**PARK CITY REGULAR PLANNING COMMISSION MEETING
SUMMIT COUNTY, UTAH
September 29, 2021**

Planning Commission Staff Report

Subject: Park City Mountain Base Area Development
Project #: PL-20-04475
Authors: Alexandra Ananth – Senior Planner
Date: September 29, 2021
Type of Item: MPD Modification

OPEN SPACE IS CALUCLATED AS AREA BETWEEN PROPERTY LINE AND FACE OF BUILDING, EXCLUDING BLUE HATCH AREAS (DENOTES AREAS EXEMPT FROM OPEN SPACE CALCULATIONS: STREETS/ROADS, DRIVEWAYS, EVA, BLDG/PKG)

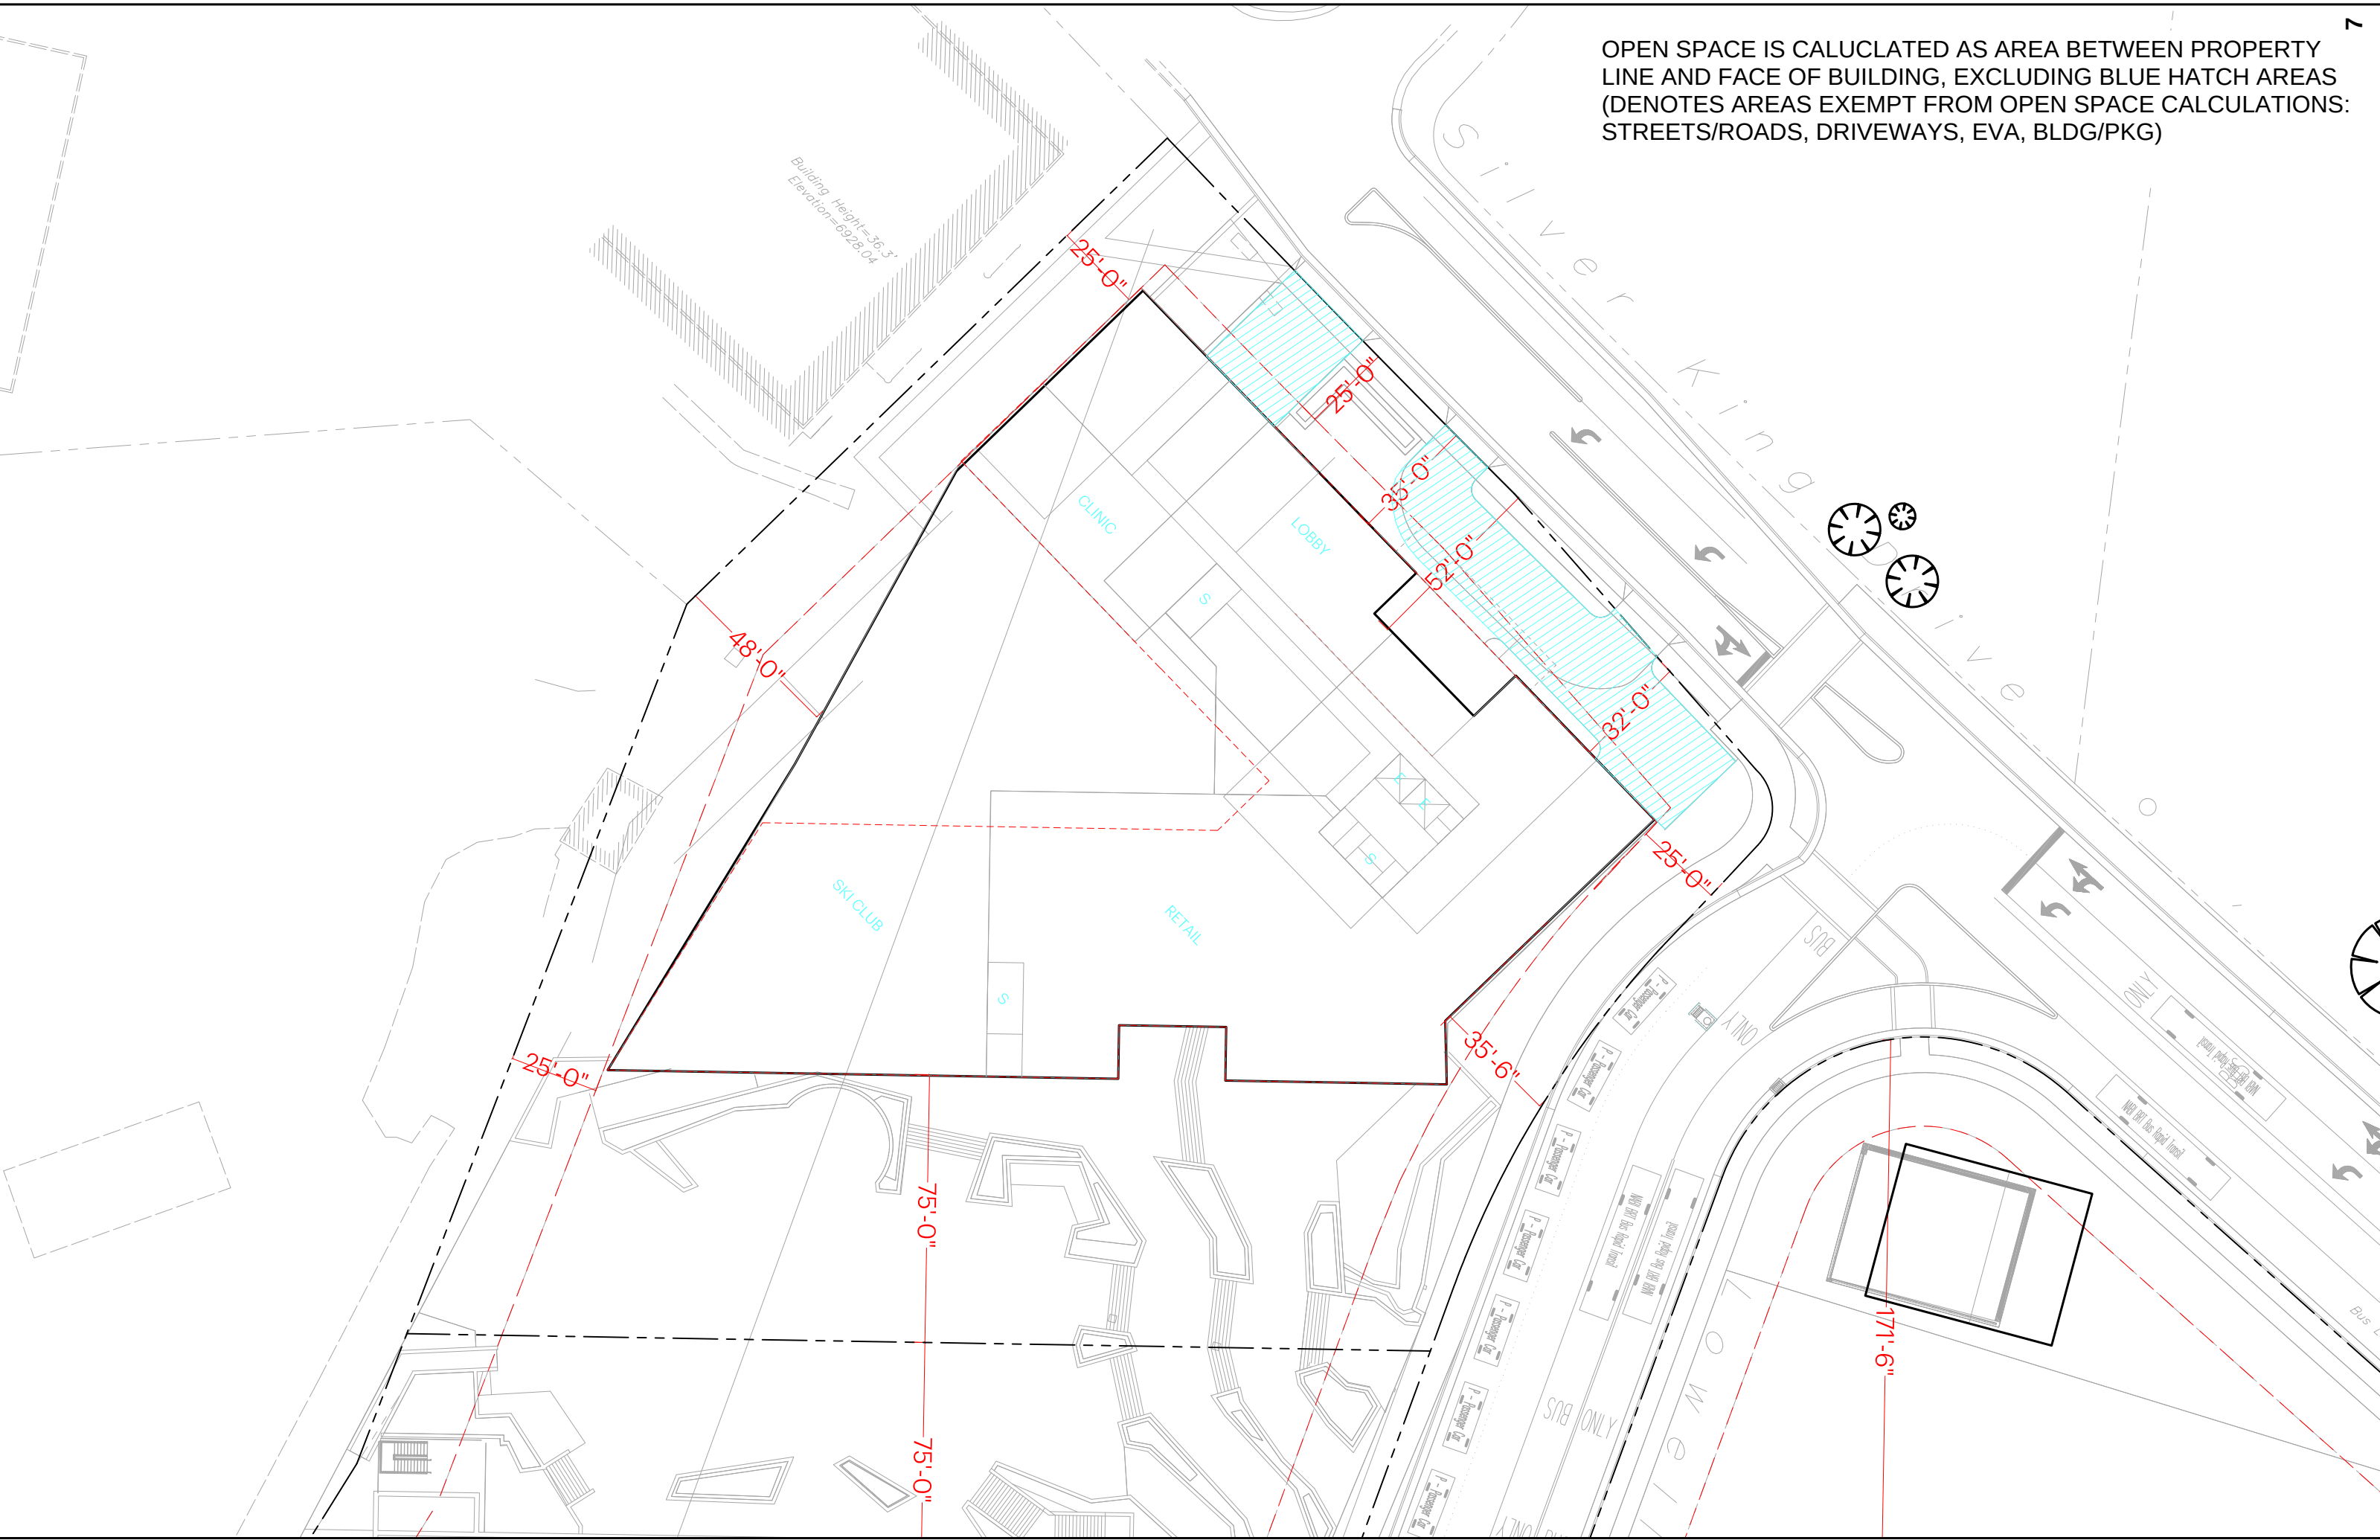
- FOF #38 - is Resort Core defined? If not delete. ***Deleted.*** Commissioner Suesser does not believe sufficient back up has been shown for this calculation. How does helipad factor in? ***The applicant resubmitted their Open Space calculations (Exhibit A). This calculation includes the 1998 Exhibit A Open Space area on the mountain, excludes all of Parcel A, and includes the paseo on Parcel B. The applicant should clarify if the ski beach and pool deck on Parcel C are open to the public and included in the Open Space calculation. Amenities open to the public may be included, but amenities that are private to hotel guests only cannot be included as Open Space. It is still not clear where the helipad will be located and if this will count against calculated Open Space.***
